1145 NW Market St.

Design Recommendation —
June 21, 2021

Project Number —
3036716

Applicant Team —
Developer: J. Selig Real Estate LLC
Architect / Landscape Architect: Mithun

EARLY DESIGN GUIDANCE REVIEW - MARKET STREET RENDERING

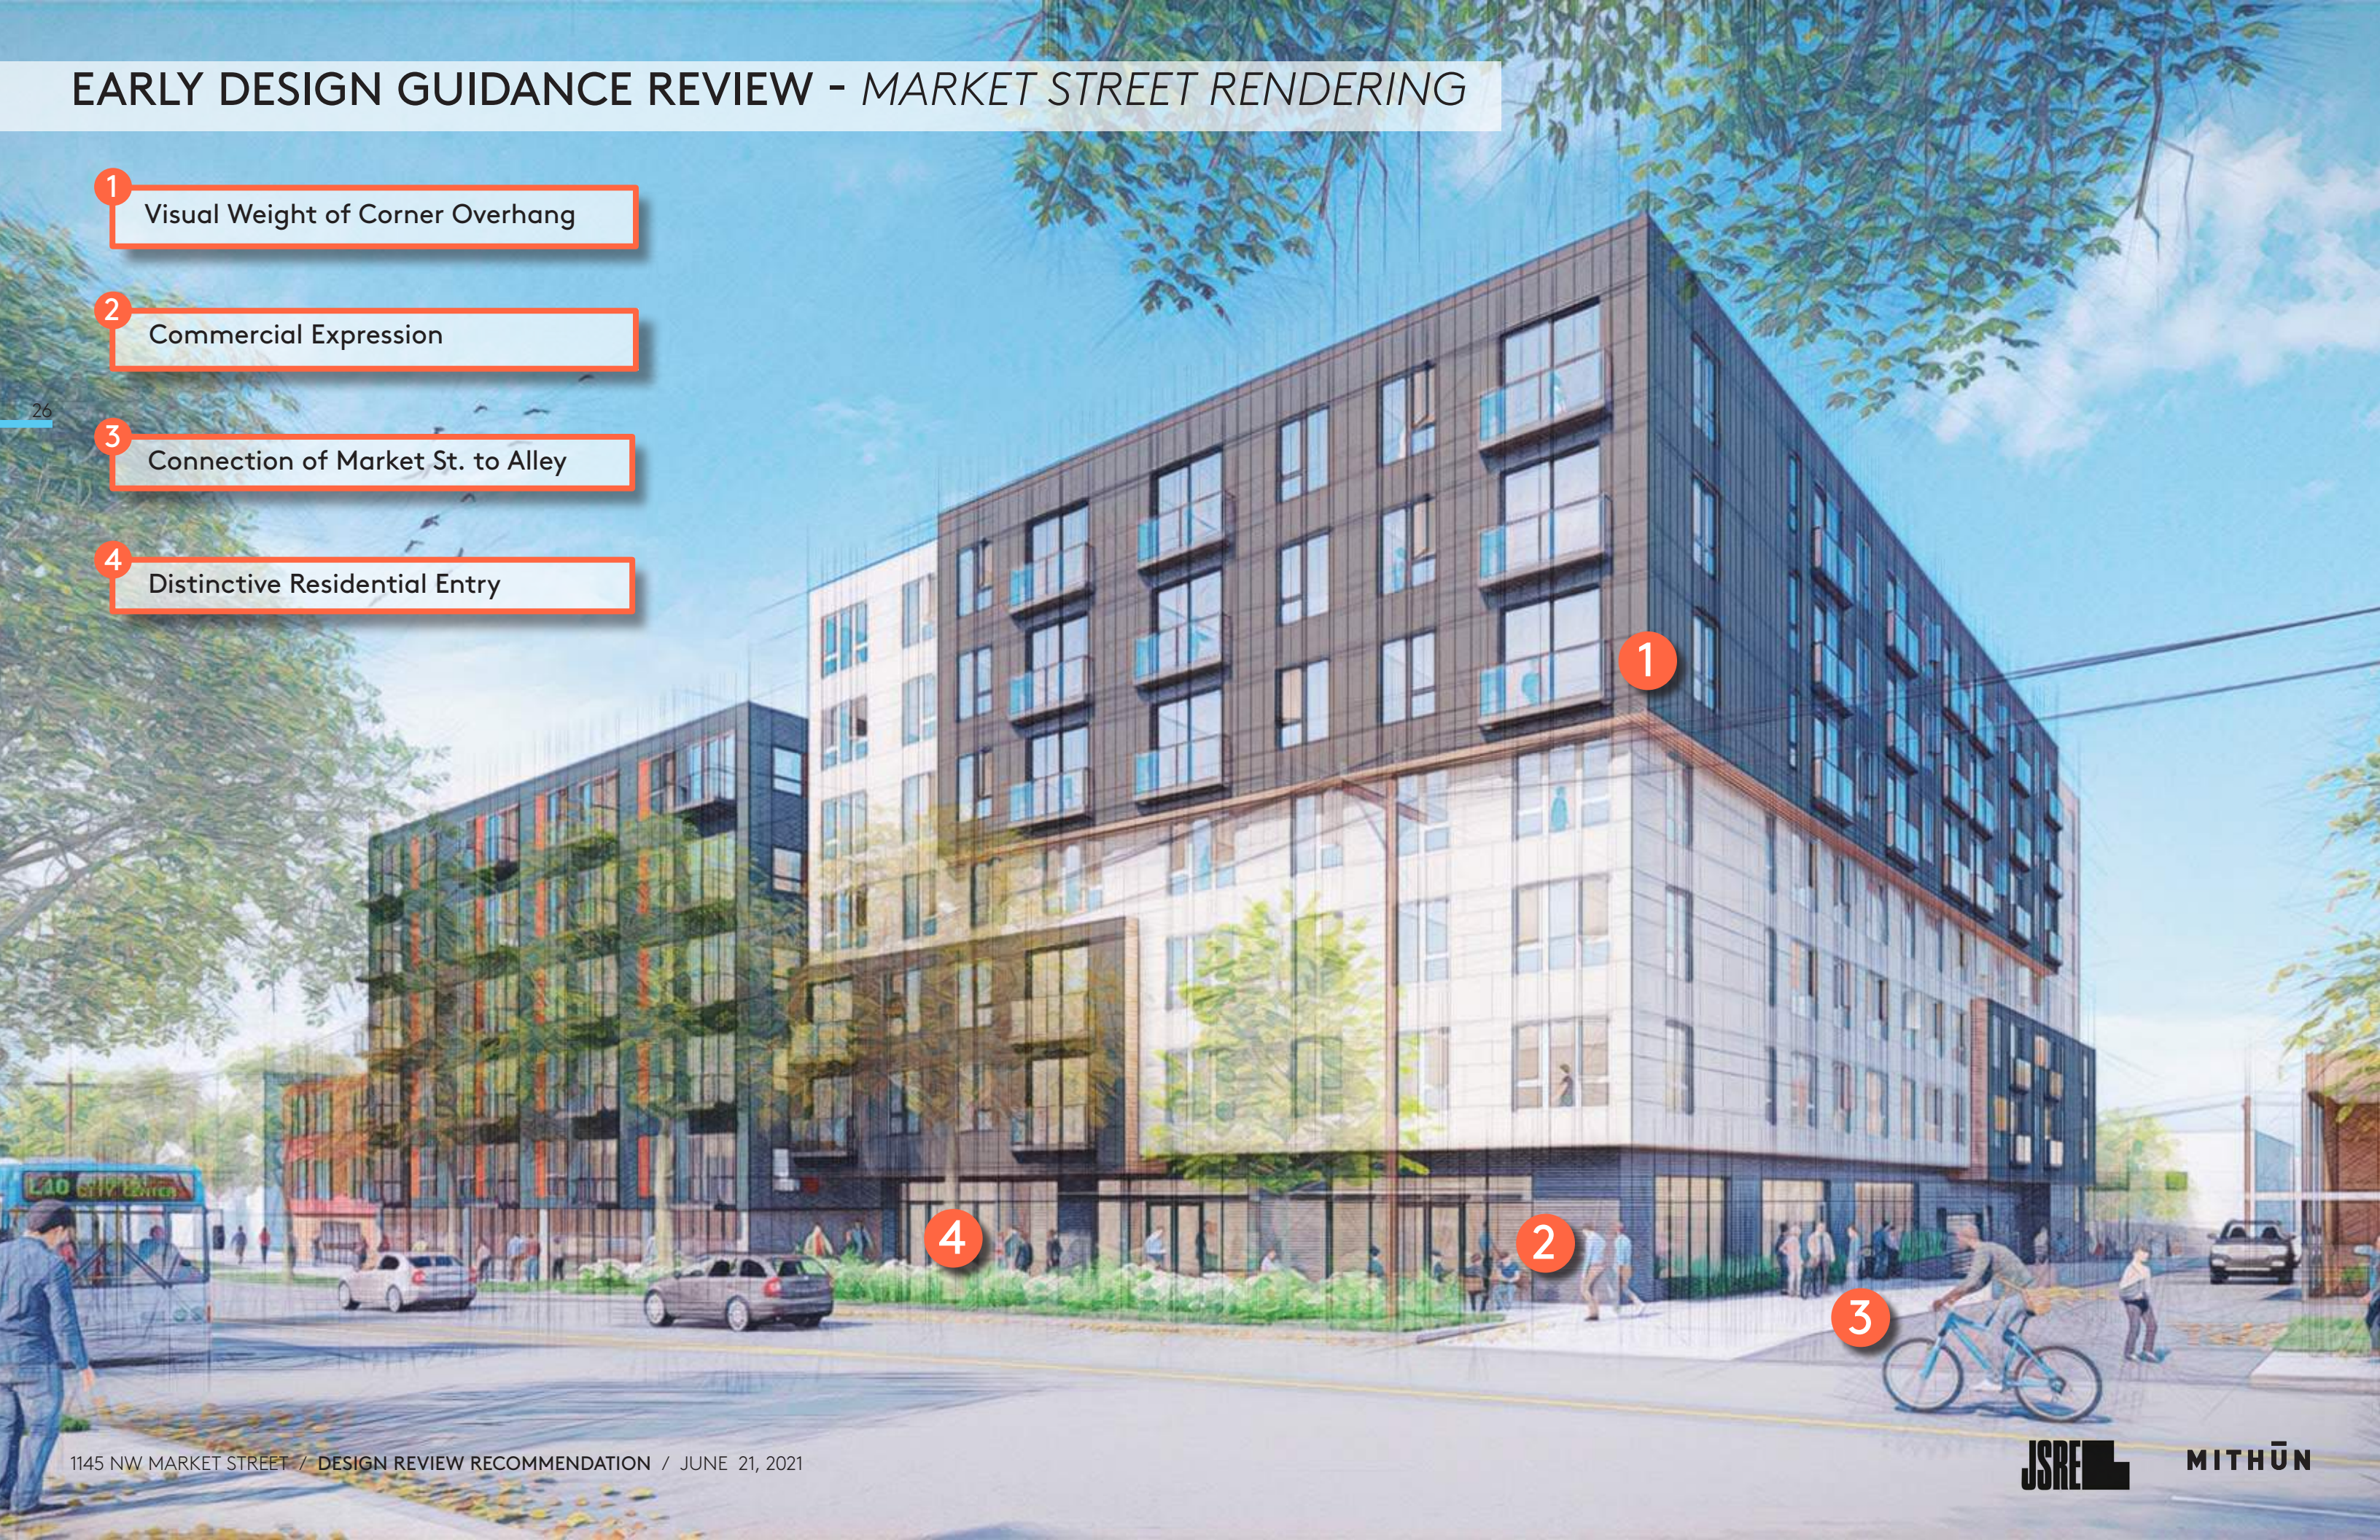
1 Visual Weight of Corner Overhang

2 Commercial Expression

3 Connection of Market St. to Alley

4 Distinctive Residential Entry

Response:
The design response mitigates the perceived weight of the upper mass by:
-Reversing the tones of the siding materials so that dark recedes
-Extending lower massing volumes toward the NW corner.
-Increasing the height of the commercial storefront
-Raising the commercial canopy
(Reference CS3-1-d, CS3-1-2).

The design response clearly expresses the natural organization of the project: Identifiable commercial use at the base (Level 1), residential use above (Levels 2-7), with integrated, organized, and restrained facade composition.

Looking south at the 1145 base at NW Market street and Alley

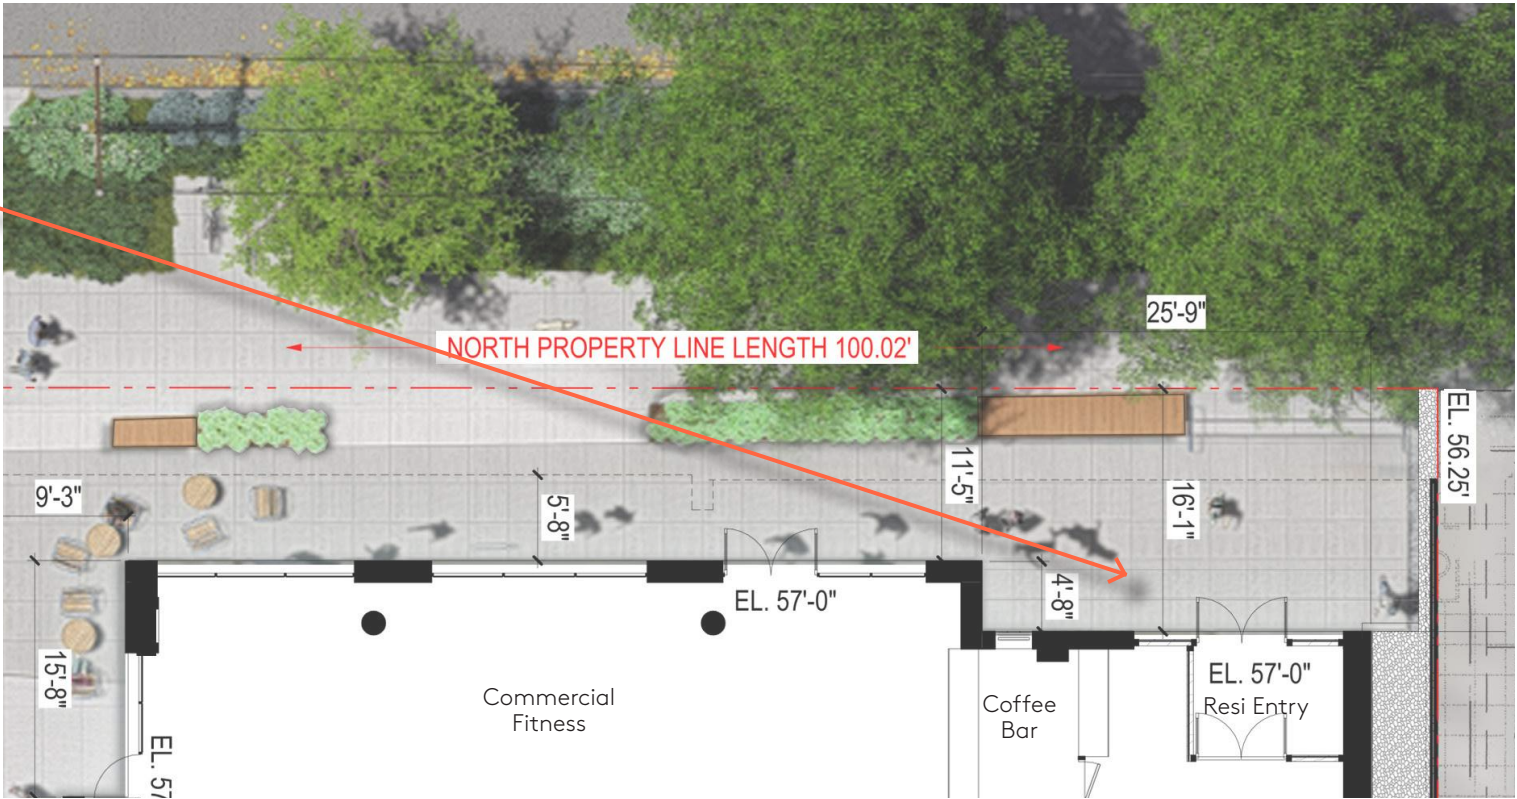
The Board was concerned that commercial use is not expressed in the massing form or façade composition, and directed further development in a manner informed by the architectural concept. The Board noted that the residential frontage along NW 54th St actually has a strong commercial character, which could inform the development of the NW Market St frontage.

The board specifically prioritized Ballard Design Guideline CS2-5-b, Along Commercial Streets, as well as CS2-5-b, and DC2-E-1.

The design team has further developed the base of the project along NW Market Street. A brick base is recessed below the residential levels above. Broad expanses of storefront glazing enliven the street edge. A canopy wraps the NW corner, linking the alley and the sidewalk. Commercial storefront entrance doors open out onto a broad expanse of embellished public promenade that extends from the sidewalk across the property line to the building. Facade transparency, a rich texture of materials including wood, masonry, metal, plantings, paving, lighting and signage, create a rich tapestry of contextually responsive urban design that enlivens the street edge.

Looking south along NW Market Street showing the distinctive warm residential entry

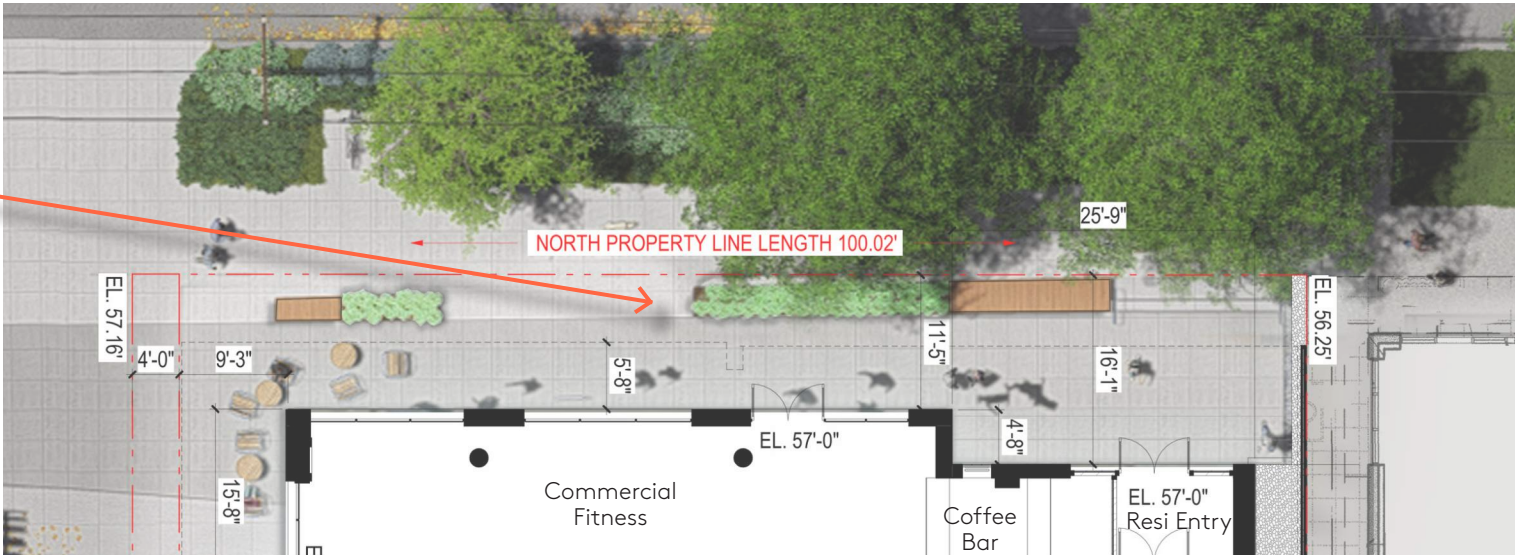
Guidance:
The Board was concerned that commercial use is not expressed in the massing form or façade composition, and directed further development in a manner informed by the architectural concept. The Board noted that the residential frontage along NW 54th St actually has a strong commercial character, which could inform the development of the NW Market St frontage.

Response:
The design team has further developed the base of the project along NW Market Street. A brick base is recessed below the residential levels above. Broad expanses of storefront glazing enliven the street edge. A canopy wraps the NW corner, linking the alley and the sidewalk. Commercial storefront entrance doors open out onto a broad expanse of embellished public promenade that extends from the sidewalk across the property line to the building. Facade transparency, a rich texture of materials including wood, masonry, metal, plantings, paving, lighting and signage, create a rich tapestry of contextually responsive urban design that enlivens the street edge.

Distinct Residential Entry

Warm wood finishes wrap the residential lobby porch to provide a distinctly identifiable residential entry that stands in contrast to the brick pilasters and aluminum framed storefront that characterize the commercial space. Signage and lighting highlight the entry.

Section at base along NW Market St

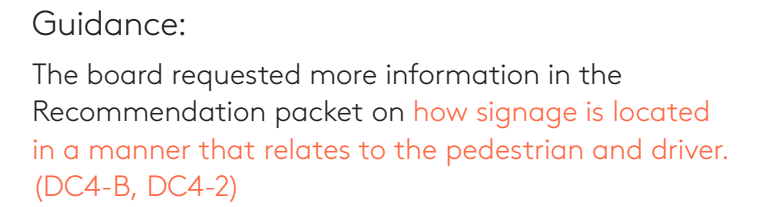
The Board recommended approaching the design of the public realm along NW Market St in three dimensions; explore how the mature trees, façade treatment and building overhangs frame the pedestrian experience and relate to the commercial use.

The Board specifically prioritized Ballard Design Guideline PL3-4, Retail Edges. (PL3-C, PL3-4)

The façade treatment along NW Market street serves two functions. First, on the eastern half, the residential entry lobby is clearly identifiable by signage, large expanses of glass, and lighting. Wood paneling highlights the entry. Second, the western half of the frontage features solid brick pilasters that frame broad expanses of floor to ceiling glass and storefront entries. This treatment wraps the corner and continues along the alley. Both commercial use and the residential entry are accessed from a broad pedestrian promenade that spans between the ROW planting strip and the building edge. An additional 8'-10' setback from the lot line provides between 16 and 18' of protected, paved pedestrian area for movement, seating, and building access. Benches, planting, bicycle racks provide pedestrian amenity. A canopy wraps the NW corner of the project to provide weather protection.

View looking east along NW Market St

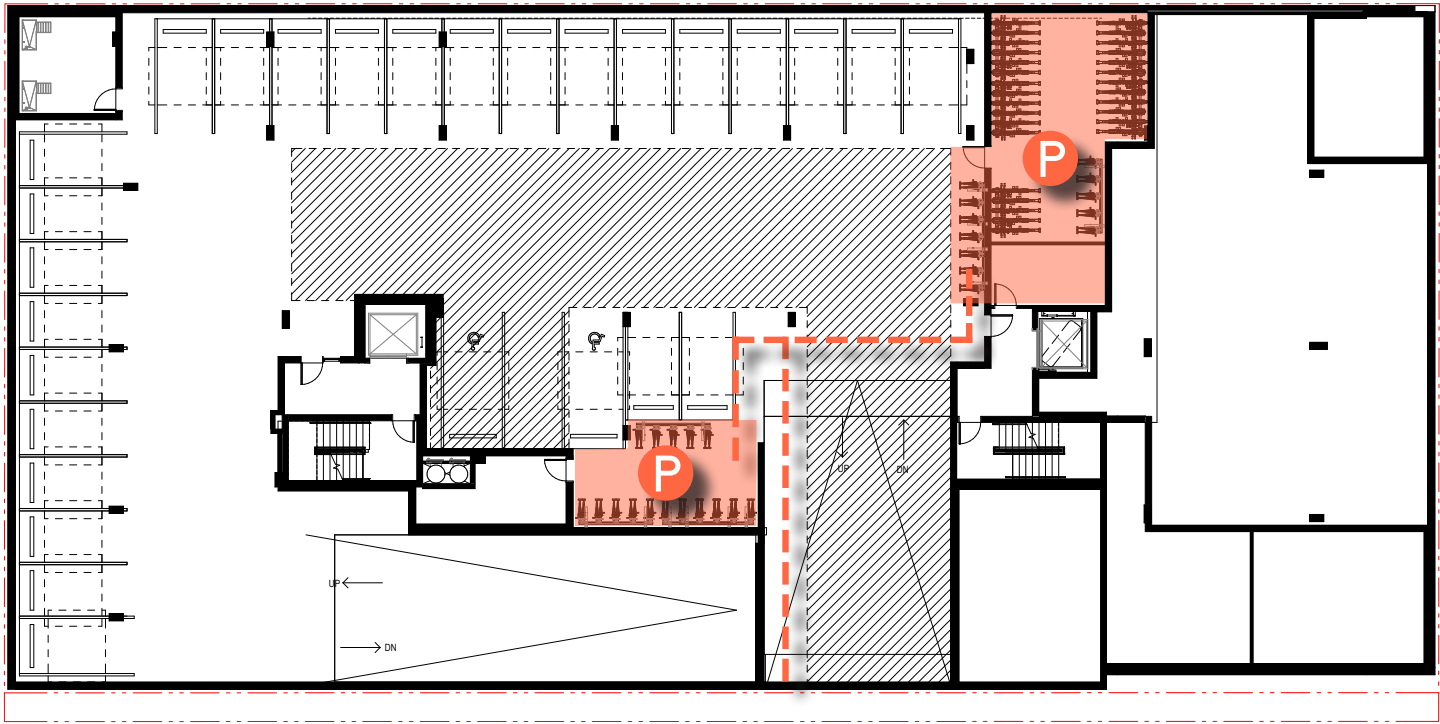
Guidance:
The Board directed further study of commercial spill out space along the NW Market St frontage, and requested more information on the relationship between interior and exterior uses at the Recommendation phase.

Response:
The design team offers further refinement of the commercial frontage along the north portion of the alley and along NW Market street. Paving, planting, amenities, signage, canopies, lighting, brick, and storefront windows create a pedestrian scaled open space along NW market street.

Reentrant Corner

A carved rebate at the northwest corner of the ground floor allows the paved commercial spill out space to flow more graciously from NW Market St. to the alley, and creates additional space for outdoor seating.

Partial ground floor plan highlighting the alley design

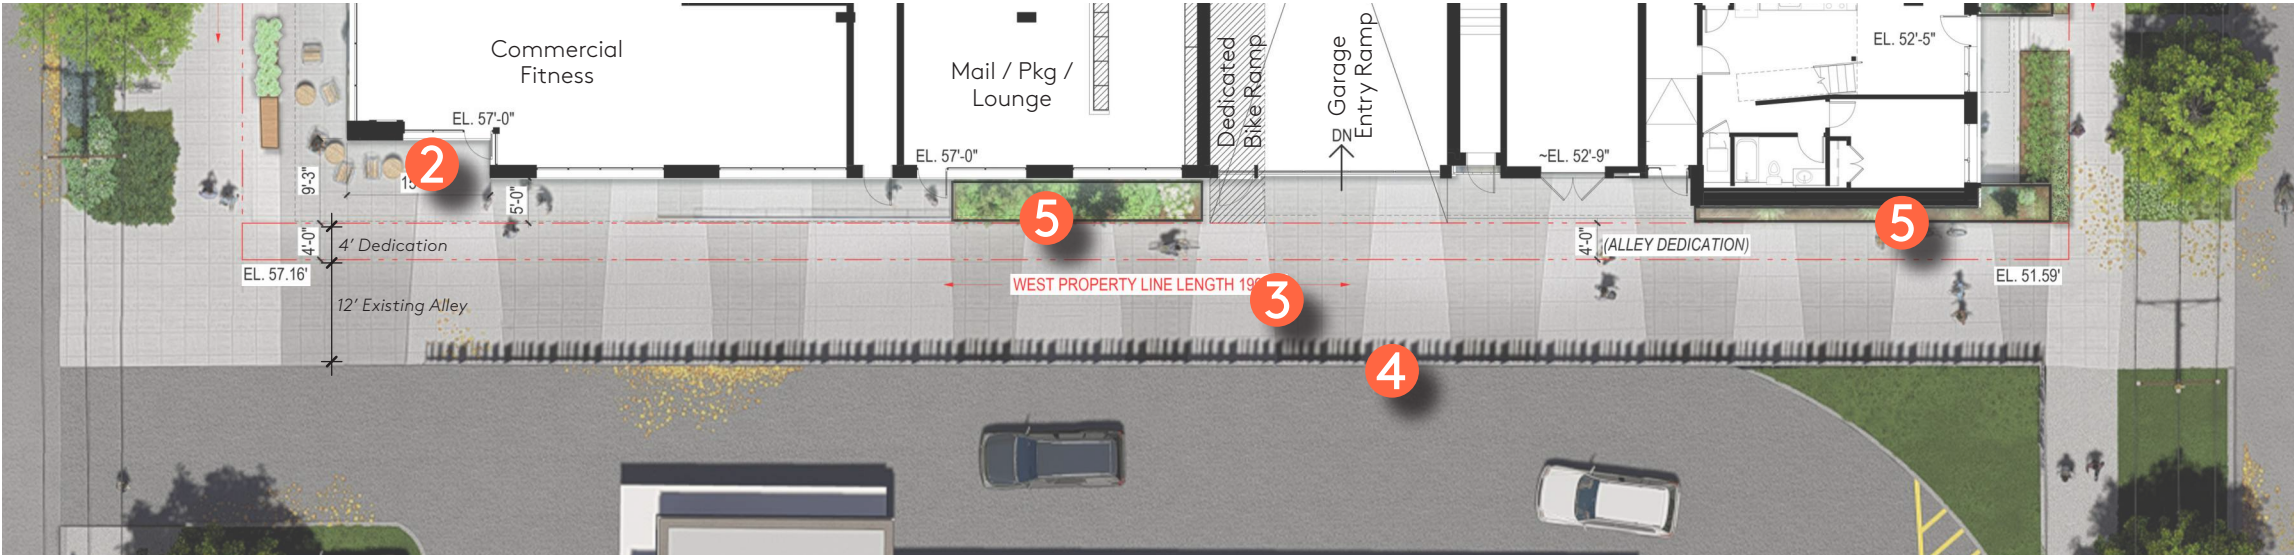
The Board supported the woonerf concept in the alley and noted it **should be designed and prioritized for pedestrian comfort, not just a place for vehicles and service access.** The Board, however, was concerned that the NW Market St frontage and alley do not feel unified, and directed further study of how the landscape design and glazing wrap the corner, how ground-level uses activate the alley, and how surface treatments indicate priority for pedestrians over vehicular users.

- 1. Canopy**
Market St. canopy wraps the corner into the alley to encourage commercial spill-out and unify the design language of the alley and street facing facade.

- 2. Reentrant Corner and Commercial Spill-Out**
The northwest corner of the ground floor is notched to both provide connectivity from the sidewalk to the alley and to encourage circulation of pedestrians through the alley from Market St. and provide additional space for seating.

- 3. Surface Treatment**
The alley shares a unique paving pattern that blends with the design of the Market St. frontage. The patterning provides visual interest and encourages pedestrian, non-vehicular activity.

- 4. Privacy Screening**
Screening provides separation from vehicular traffic and limit the light trespass from the neighboring McDonald's drive-thru.
- 5. Planters**
Planters located along the edge of the alley improve its spatial quality, softening and humanizing its perimeter.
